Proposed Changes for SPI-4

00-246r8

Paul Aloisi TI

The driver/receiver electrical changes proposed for SPI-4

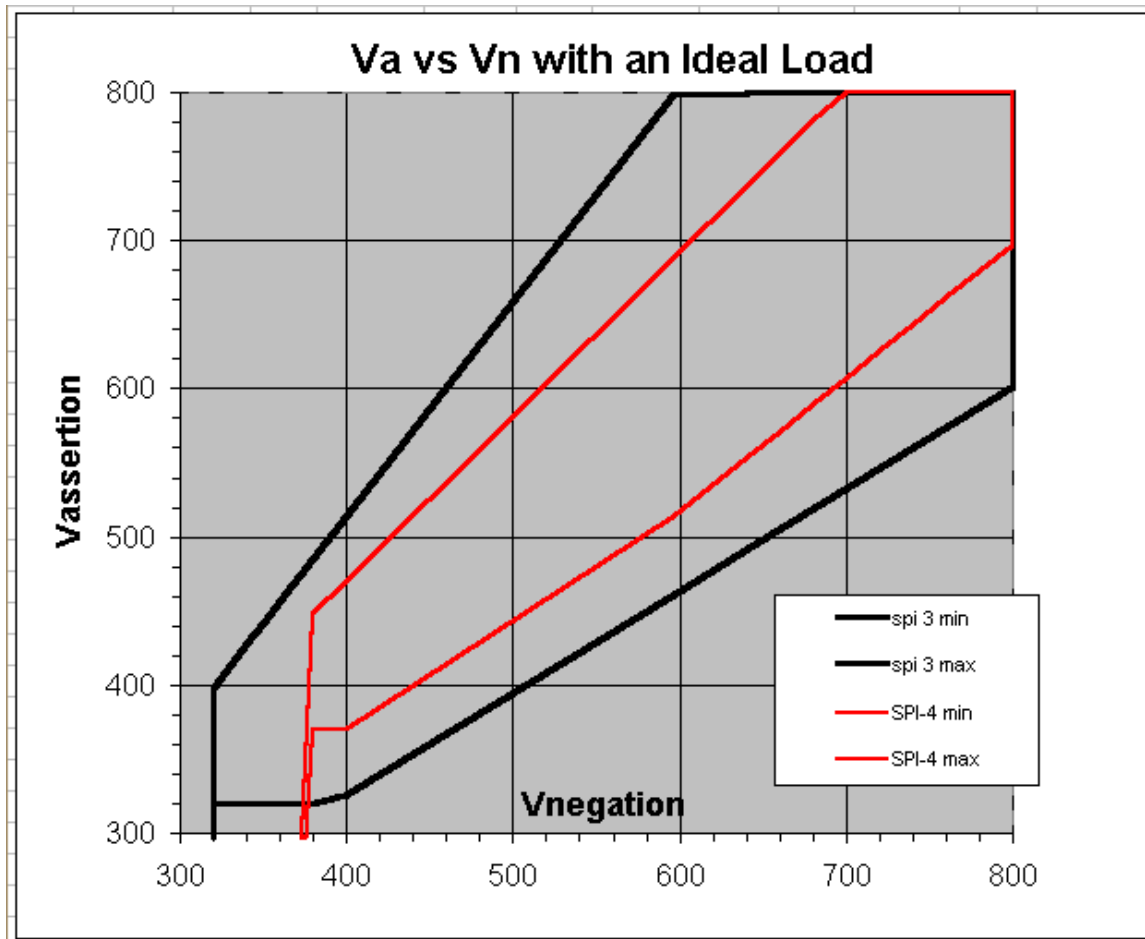
The driver asymmetry equation from the July meeting is wrong. The equations should be $V_a = (0.9 \cdot |V_n|) - 23$ Minimum and $(1.11 \cdot |V_n|) + 26$ Maximum

Table A.2 Assertion V_a equation for Fast-160 must change to $V_a = (.9 \cdot |V_n|) - 23$ Minimum and $(1.11 \cdot |V_n|) + 26$ Maximum

Change fall back to 50 to 66% from 60 to 78%

Figure 49 Paced Timing diagram and the paragraph under the figure TBDs replaced a table expect for the free running clock which is 100 mV.

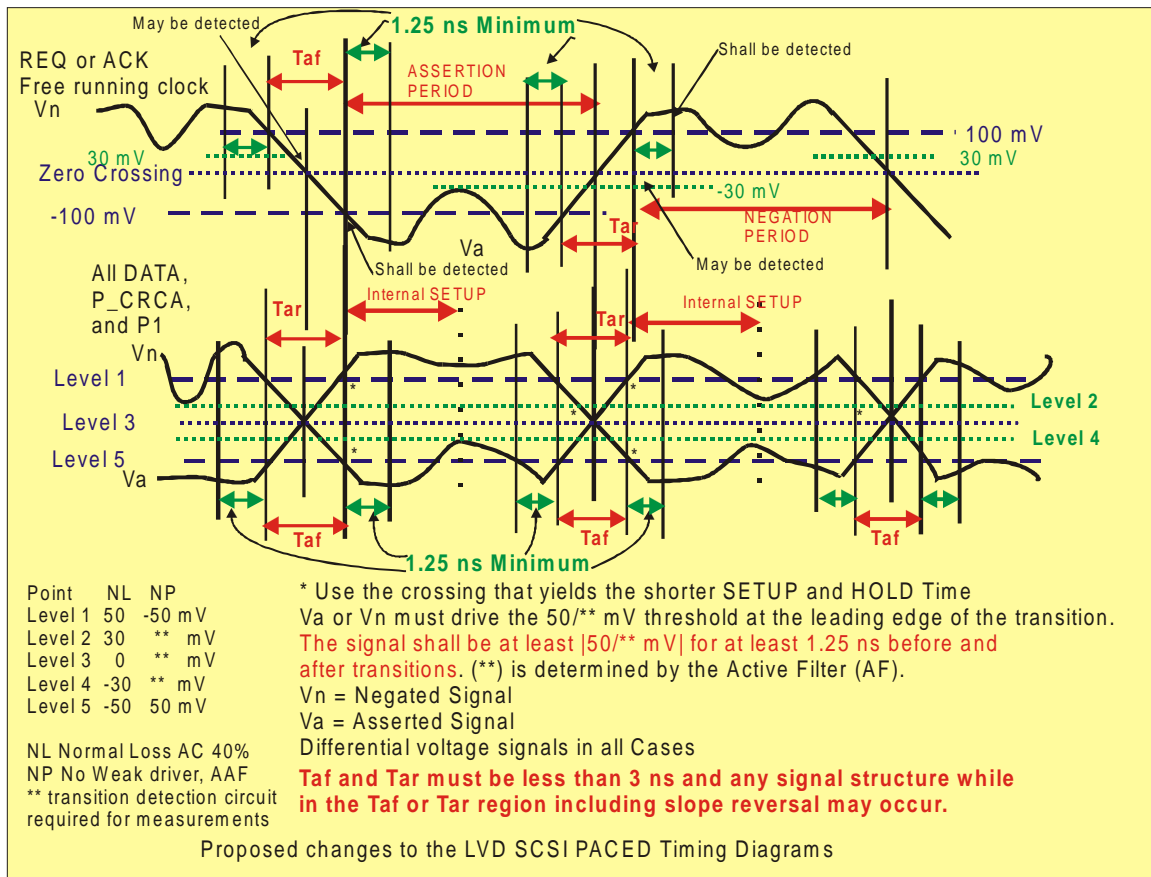
The changes proposed:

Normal Loss (NL) (Proposed –AAF receiver only, this paragraph is for reference only)
 The Free running clock shall transition for NL (normal loss systems) from -100 to +100 mV or +100 to -100 mV in 0 to 3 ns, the waveform between -100 and +100 mV is not otherwise specified. The other signals, the first transition from the multiple bit level shall transition -100 to +50 mV or +100 mV to -50 mV, if there is an immediate transition the +50 mV to -100 mV or -50 mV to +100 mV. The absolute value of the signals shall remain above the 100 mV multiple bits or 50 mV for a single bit level for 1,25 ns at each end of the transition. The absolute value of the signals shall not drop below 30 mV except during the transitions (see 7.3.2).

The Free running clock shall transition for NP (no weak driver systems) from -100 to +100 mV or +100 to -100 mV in 0 to 3 ns, the waveform between -100 and +100 mV is not otherwise specified. The other signals, the first transition from a multiple bit level shall transition at least 200 mV and shall be a minimum 50 mV from the zero crossing, example -300 mV level shall transition to -50 mV for a valid transition.

The absolute value of the multiple bit signals shall remain above the 100 mV for 1,25 ns at each end of the transition. The absolute value of the signals shall not drop below 30 mV except during the transitions (see 7.3.2).

Figure 51 and 52 Receiver Mask paced data transfer

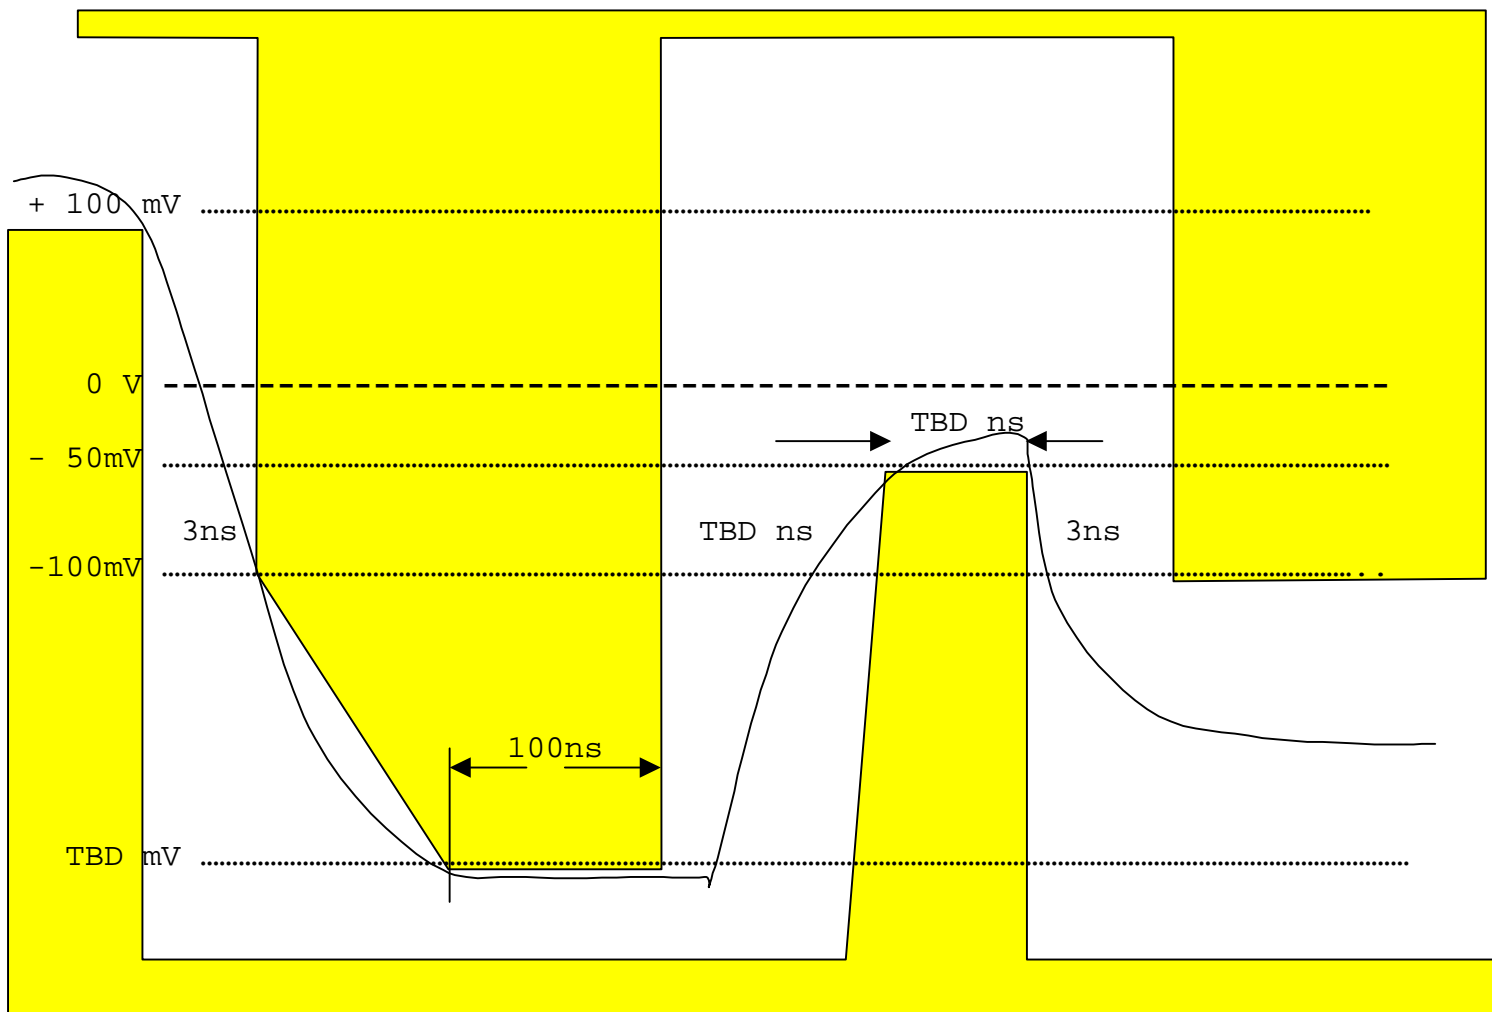
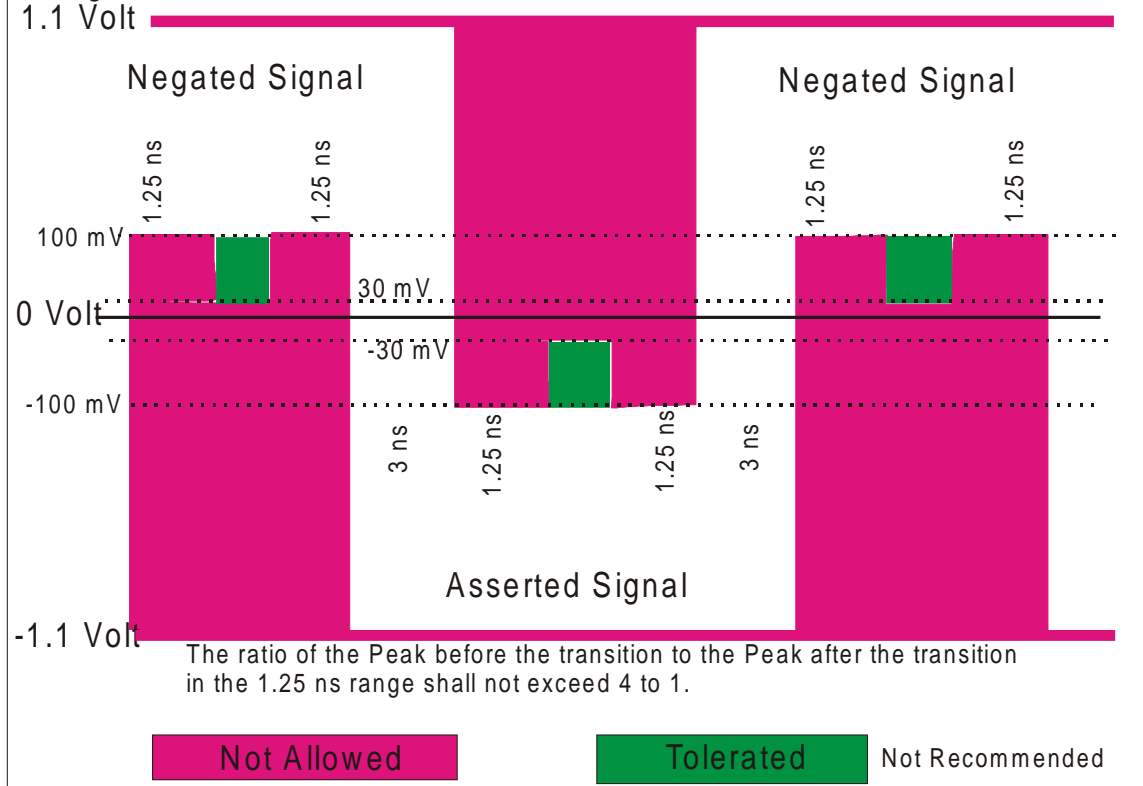
Replaced with Dick Uber's drawing 00-347

Fast-160 Receiver Mask for free running clock and non isolated transitions, during the data transitions +/-1.1 volt maximum with reflections
